# TECHNICAL BULLETIN

No. 205-00-111

**MODEL AFFECTED:** 205A-1

**SUBJECT:** FIN SPAR CAP 212-030-447-001/-101,  
REPLACEMENT OF.

Figure 2

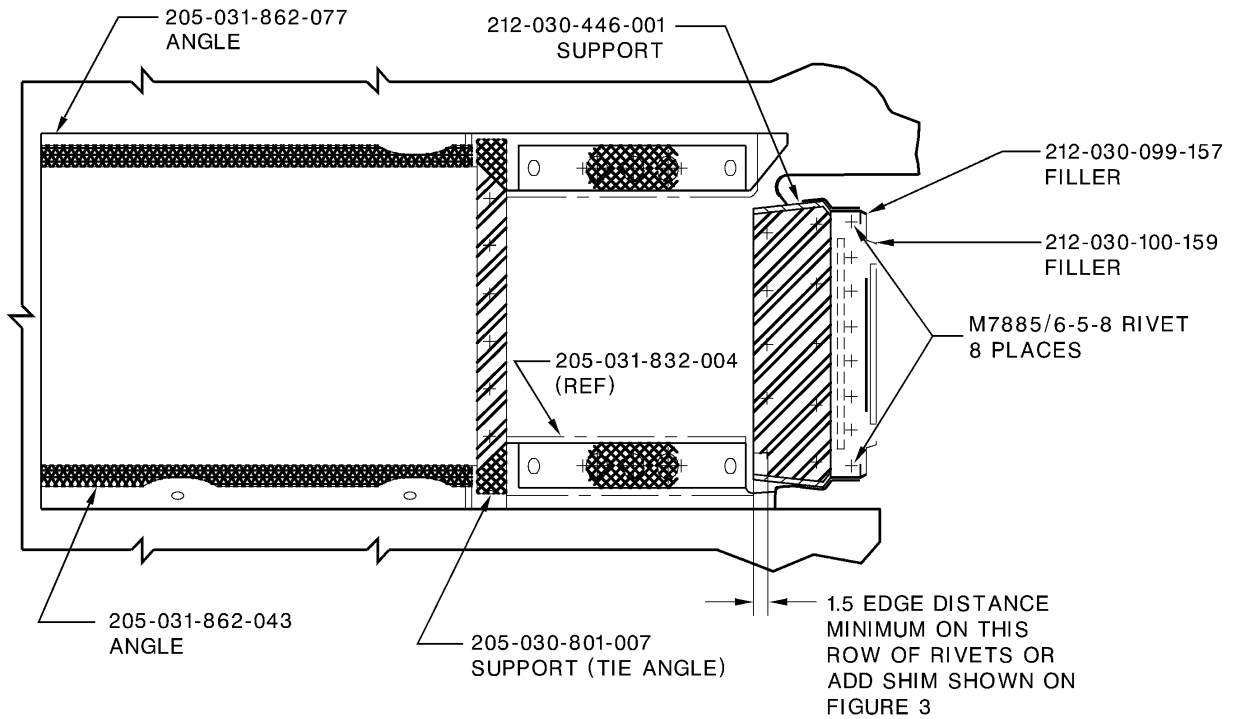
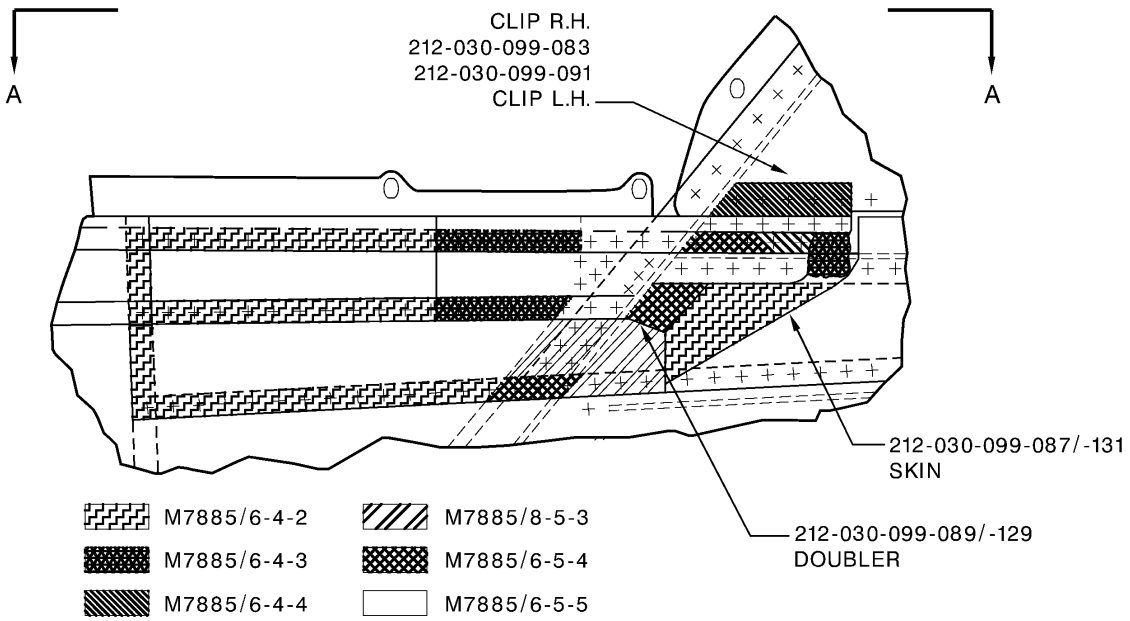
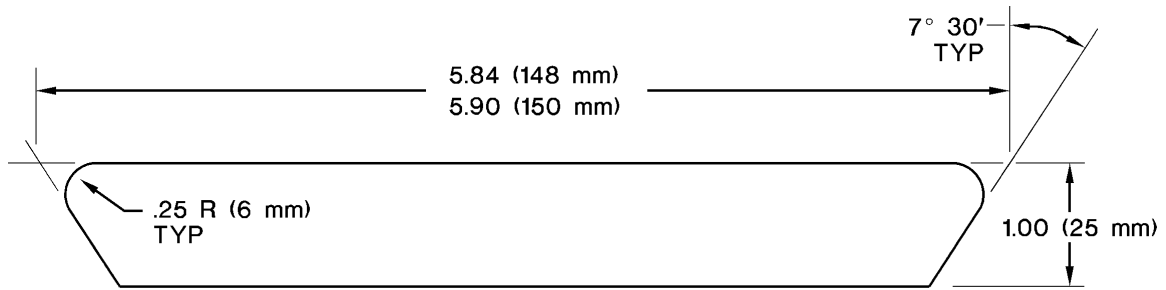
3. Remove clips P/N 212-030-099-091 and -093. See figure 2.
4. Remove support P/N 212-030-446-001 and associated fillers and shims. See figure 2, view A-A.
5. Remove rivets aft of tailboom station 175 that secure drive shaft cover angles P/N 205-031-862-043 and -077 to top surface of fin splice. See figure 2, view A-A.

6. Remove the (qty 8) MS20426AD3 rivets that attach the 42-degree gearbox attach nutplates to the supports and skins, if required. Referring to figure 2, remove doubler P/N 212-030-099-089/-129 and skin P/N 212-030-099-087/-131, by removing fasteners securing parts to tailboom. Slide skin and doubler assembly aft up along spar until clear of bulkhead and tailboom skin. Slide assembly forward, then slide parts from under angles P/N 205-031-862-043 and -077. Clean sealant from parts using plastic scraper, Scotch-Brite and Methyl-Ethyl-Ketone. Verify that skin and doubler assembly is still properly bonded. Refer to ASB 205-93-56.
7. Remove rivet attaching stiffener (tie angle) P/N 205-030-801-007 to left support P/N 205-031-832-004. Refer to figure 2, view A-A.

26. Prime any bare metal with primer (C-204).
27. Locate new support P/N 212-030-446-001S, fillers P/N 212-030-099-157 and 212-030-099-159 in place on skin and doubler and against face of spar as shown in figure 2, view A-A. Check edge distance on forward most holes in the 212-030-446-001S support (see figure 2, view A-A). If edge distance is less than 1.5, make a shim as shown in figure 3 and install it on top of filler 212-030-099-159. Transfer existing holes from structure. NAS9310M5 or M7885/8-5 fasteners (qty 10 required) may be used for the installation of the 212-030-446-001S support horizontal flange to the top of the tailboom skin and doubler. See figure 2, view A-A. Install fasteners with wet primer (C-204).

28. Install MS20470AD5 and MS20470AD4 rivets of proper grip length in all remaining locations where holes have not been enlarged and access for bucking is available. Skin and doubler will be attached using Cherry MAX or Bulbed Cherry LOCK rivets. Using figure 2 as a guide, verify such holes are as follows: all (-4) rivet holes are 0.143 to 0.146 inch diameter and all (-5) rivet holes are 0.176 to 0.180 inch diameter. Make sure that all parts are pulled together.

Figure 5

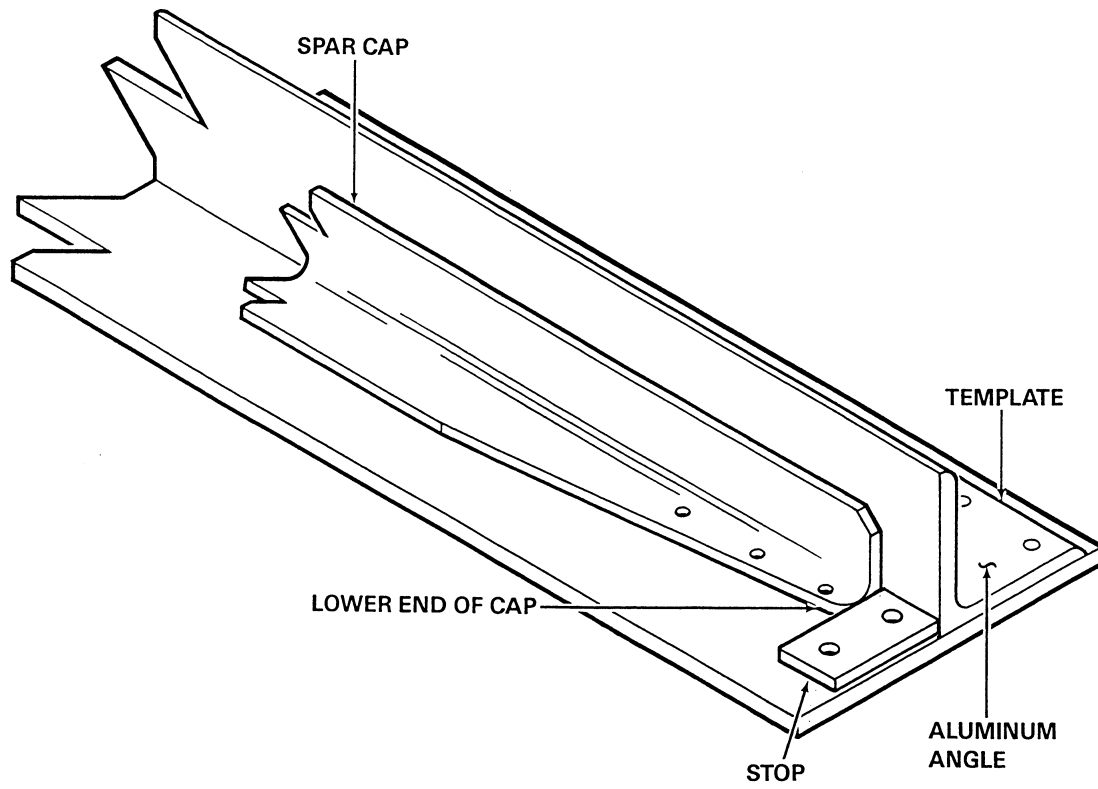
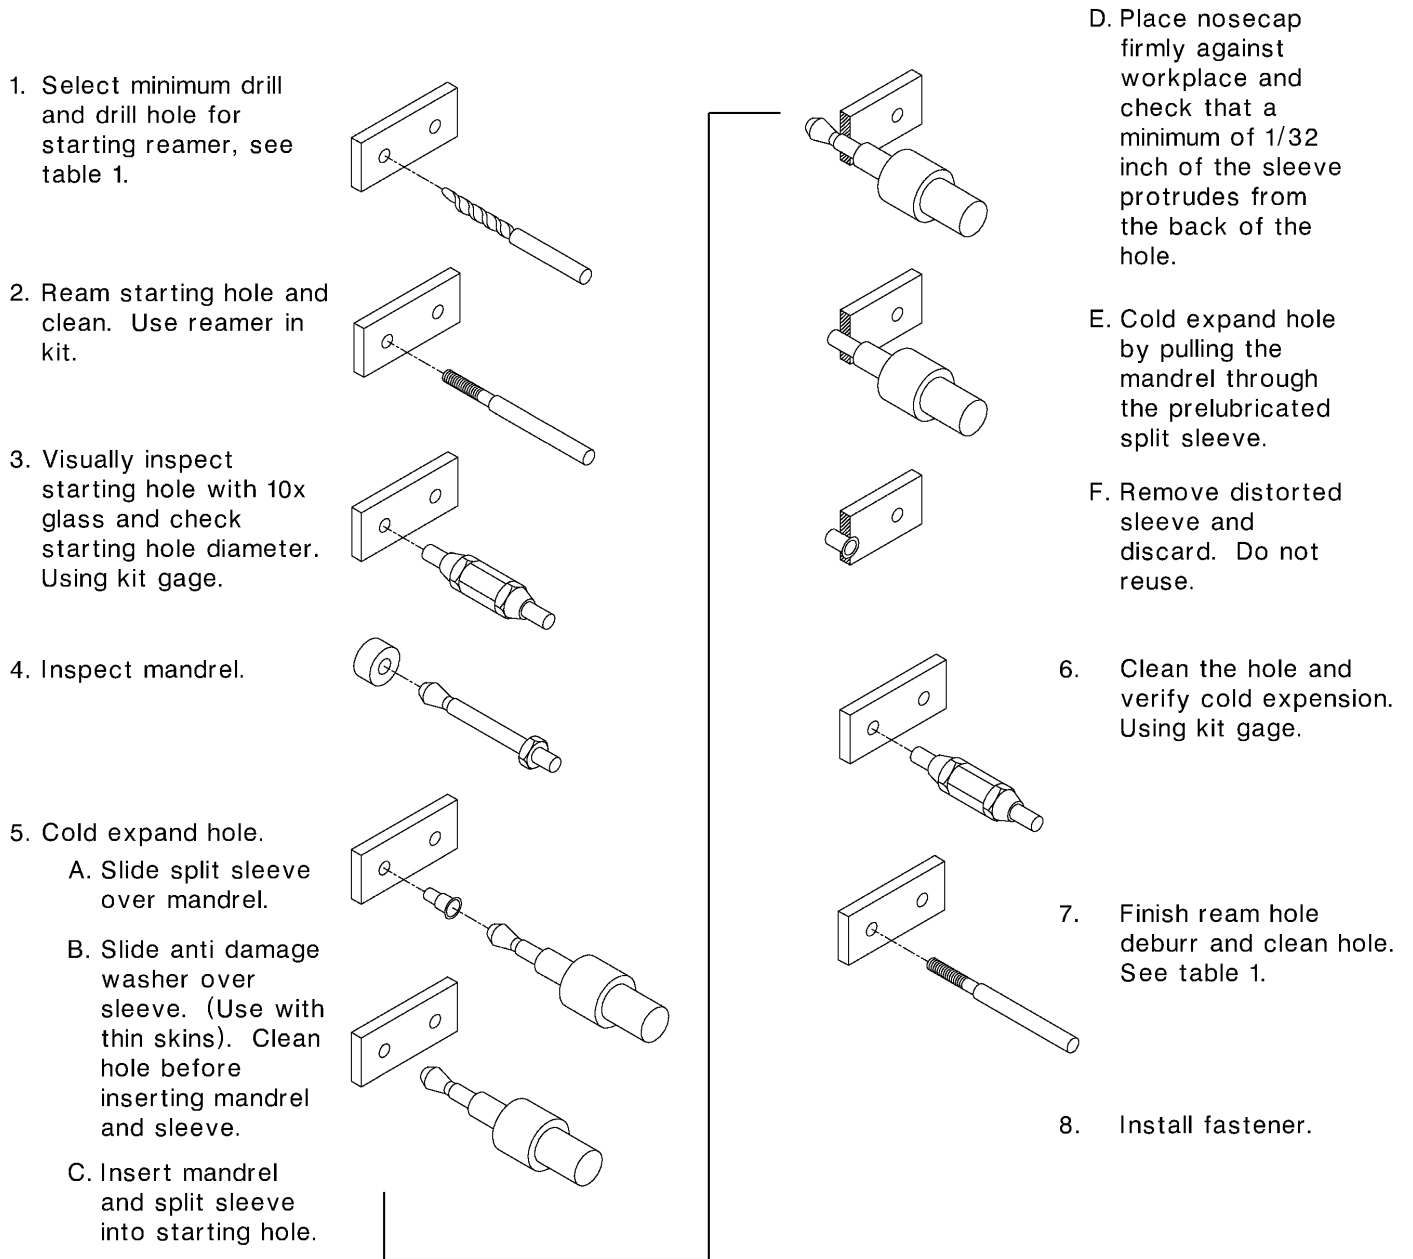
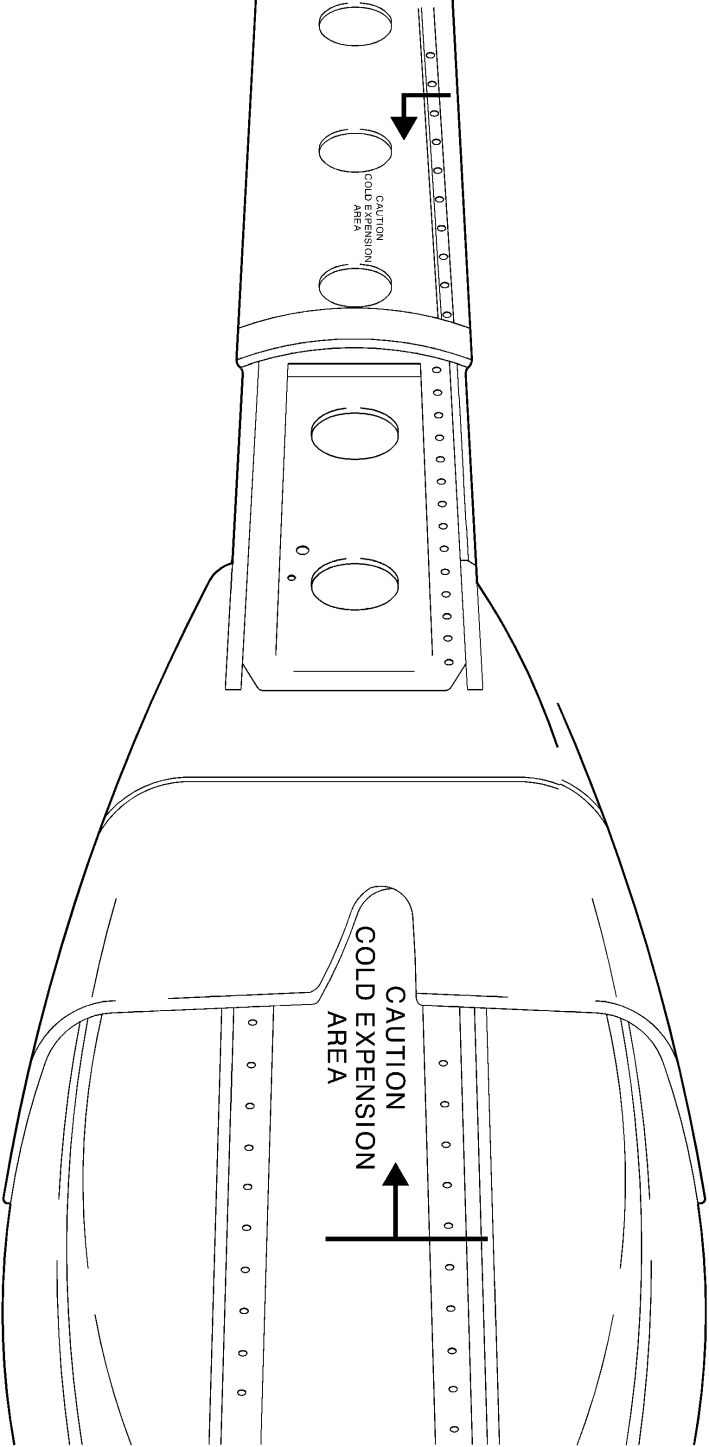
11. Inspect all existing holes in the removed cap for minimum edge distance of 1.5 (refer to attachment B and C). Any hole with low edge distance in the cold expansion area will be identified and not transferred to the template. It will be relocated in the cap to obtain a satisfactory edge distance. A small local repair can be done to the adjacent sheetmetal using instructions in chapter 3 of the "Structural Repair Manual". This inspection will also apply to any hole that will be oversized in later steps.
12. Fabricate spar cap drill template per figure 5.

- c. Spray template with machinist ink or any suitable coating to provide surface for marking template.
- d. Place bottom end of original spar cap on strap against stop with other leg against angle (refer to figure 5). Clamp in place. Make a note of the clamping sequence so that the same sequence may be used in later steps. Scribe a line around the spar cap on the template as a reference.

**Figure 6**

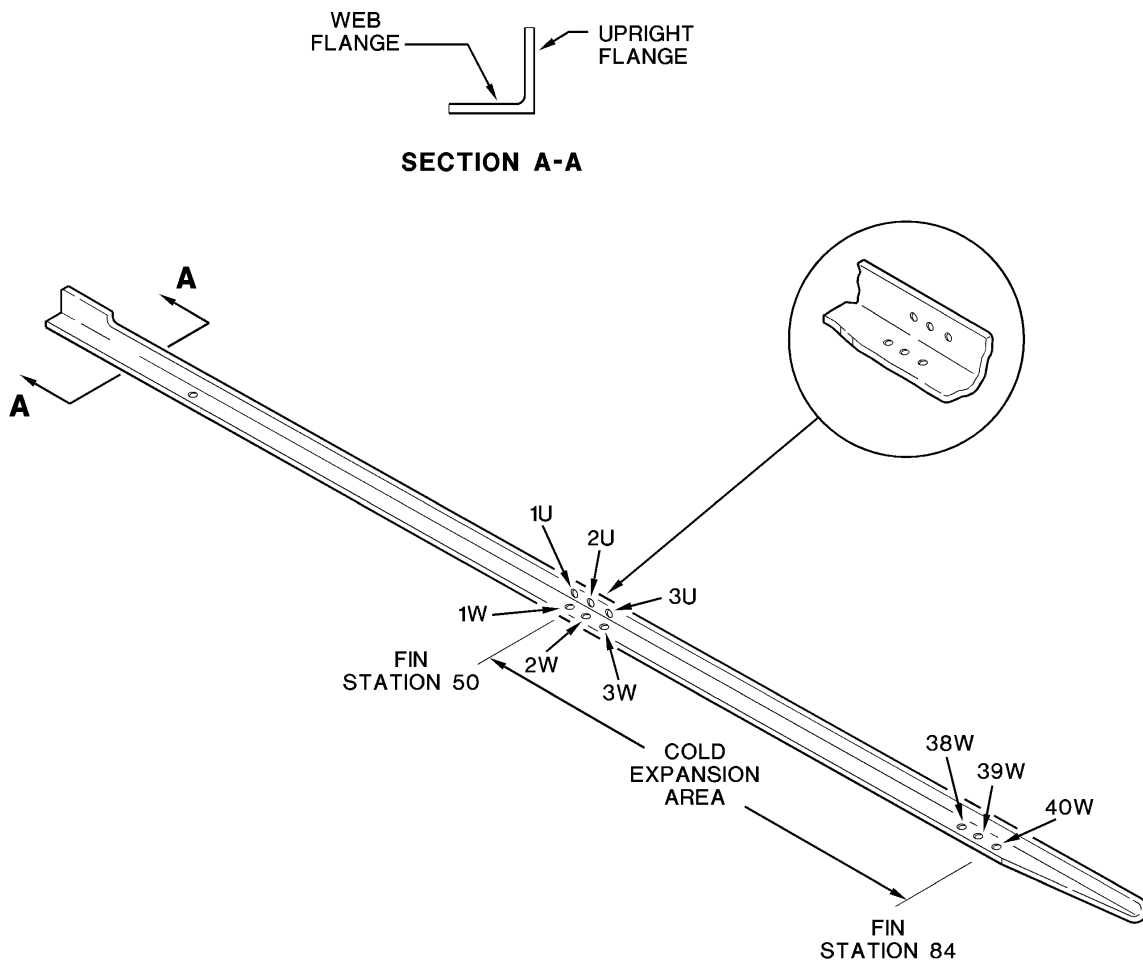
13. Clamp new spar cap P/N 212-030-447-117S in place in template. Scribe a line around the new cap to compare to the line scribed from the old cap. This is used only as an indication of edge distance problem areas. The new cap should be marked with a pencil or marker prior to drilling to verify all edge distances.
14. In cold expansion zone of the new spar cap, pilot-drill Cx start-drill holes from template. Using drill block, open holes to Cx start-drill size. Do not use drill block on Hi-Lok holes except for holes common to new support P/N 205-031-832-006 (replacing -004 support). Do not open (qty 2) holes common to bellcrank support at this stage. Carry out Cold Expansion process on holes in specified area (refer to figure 6).

Any hole that does not meet requirements of step 7 of figure 6, attachment B and table 1 dimensions will be cause for rejection of entire spar cap. Therefore, it is advisable to complete the Cold Expansion process before other holes are drilled.

- c. Locate holes for bellcrank support (refer to TB 205-86-67).
  - d. Remove spar cap from fin. Start ream and cold expand these holes as per figure 6.
  - e. Attach spar cap back into fin with clecos.
  - f. Finish ream holes (step 7 of figure 6). Remove spar cap and deburr all holes.
17. Touch up damaged paint areas and blend out damage on the spar cap that may have occurred during drilling, reaming and clamping operations. Attach spar cap back into fin with clecos.
